Technical Service Bulletin

NUMBER: 24-23-99

Revised Air Conditioning Suction Line And Unified Line Installation Instructions

2000 (PL) Neon (Left Hand Drive Only)

FIGURE 1

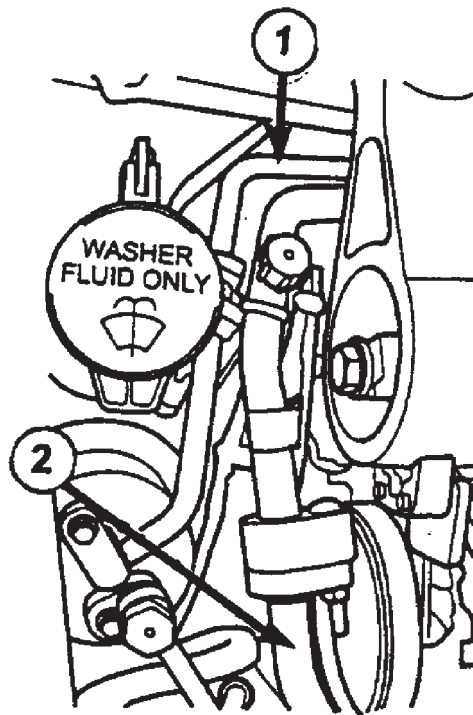
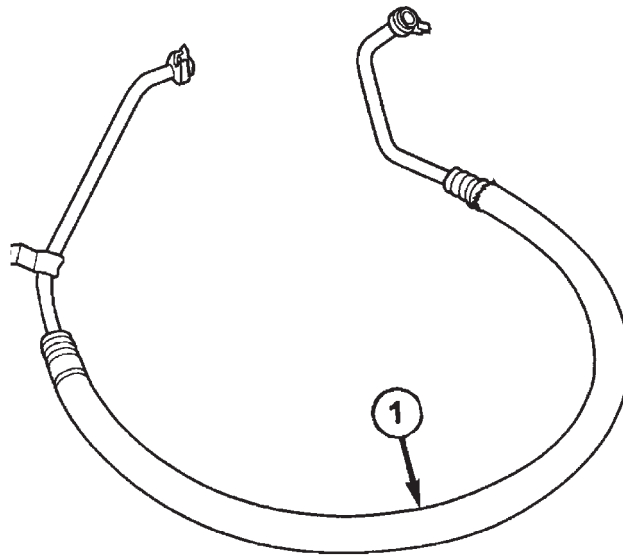
2. Remove and discard the A/C unified line by removing the bolt at the filter drier bottle, the bolt at the dash panel and the bolt at the suction port of the compressor. Do not remove the filter/drier bottle and liquid line. Do not leave the filter/drier bottle exposed to air for any length of time to prevent moisture contamination.
3. Place a rag over the power steering belt to catch oil drips.
4. Install the new A/C suction line (p/n 05278761AB) and A/C unified line (p/n 05015344AC). The new suction line will use the alternate A/C compressor bolt hole. Torque the bolt at the dash panel to 22.5 Nm (200 in.lbs). Torque the nut/stud to 11.8 Nm (105 in.lbs). Torque the filter drier bolt to 11.2 Nm (100 in.lbs). Torque the A/C compressor bolt to 12.2 Nm (108 in.lbs). (Figures 1 and 2).

FIGURE 3

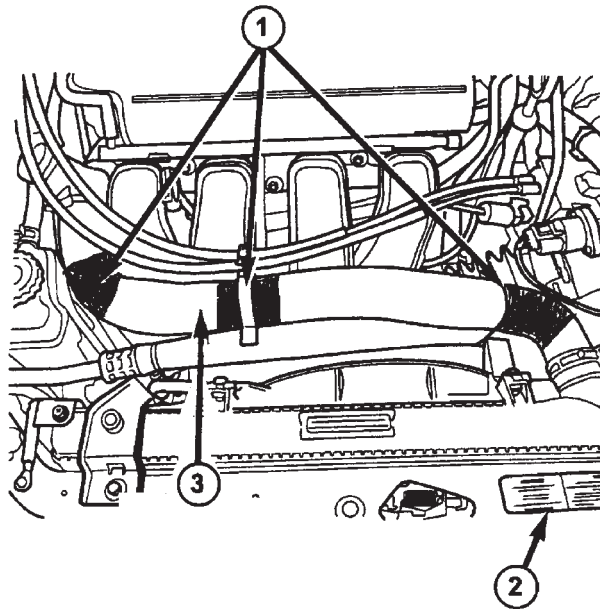
5. Evacuate the A/C system.
6. Siphon enough coolant through the coolant cap to allow removal of the upper radiator hose.
7. Install the radiator hose sleeve (05017627AA) by sliding the braided sleeve over the hose. Secure the hose with the three rubber bands provided (Figure 3).

12. Install the new A/C underhood specification label (p/n 05264840AC) over the existing label (Figure 3).

FIGURE 4

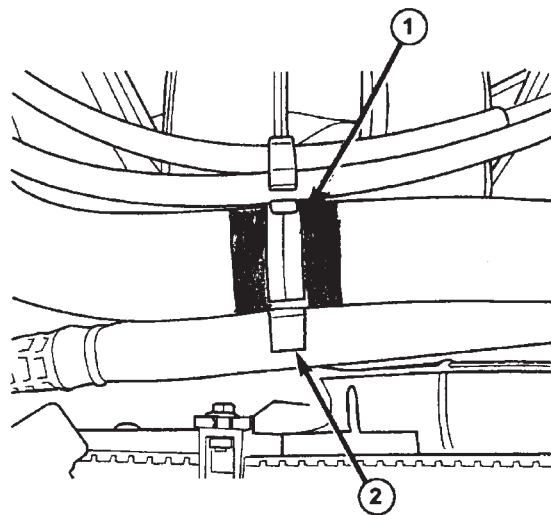
8. Install the accelerator cable clip over the center rubber band (Figure 4).
9. Install the fan shroud clip (p/n 05278762AA) with the existing left side cooling fan shroud mounting bolt and torque to 7.3 Nm (65 in.lbs) (Figure 5).

FIGURE 6

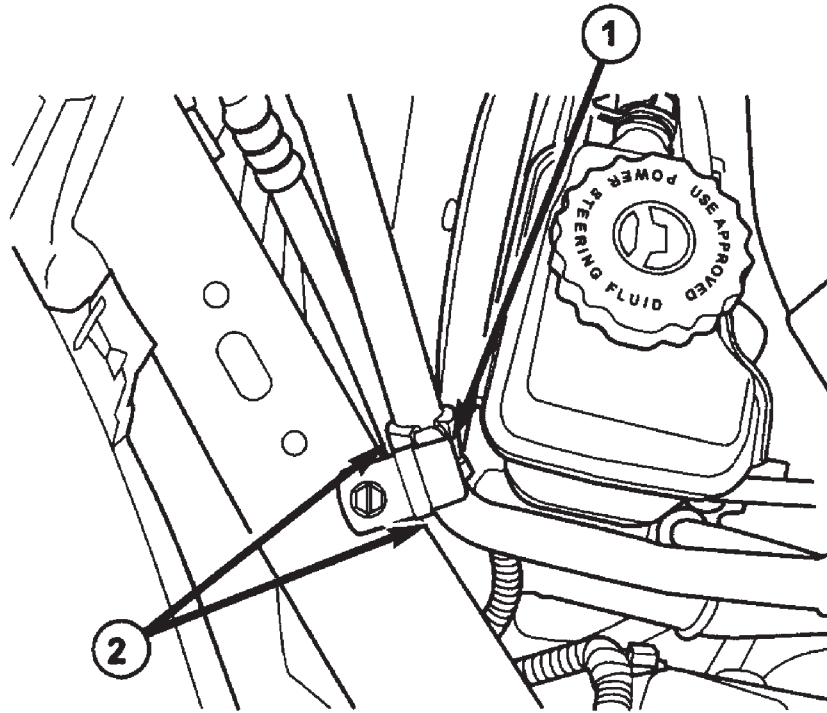
NOTE: ENSURE THAT THE PILOT HOLE IS POSITIONED SO THAT THE CLIP DOES NOT CONTACT THE POWER STEERING RESERVOIR (FIGURE 6). ALSO ENSURE THAT THE ALUMINUM TUBING DOES NOT CONTACT THE SHEET METAL OR A BUZZ MAY OCCUR.

11. Using the scribe mark made in step 10, drill a 7/32 pilot hole into the radiator crossmember. Install the crossmember clip screw (p/n 06505529AA) and torque to 7.3 Nm (65 in.lbs).
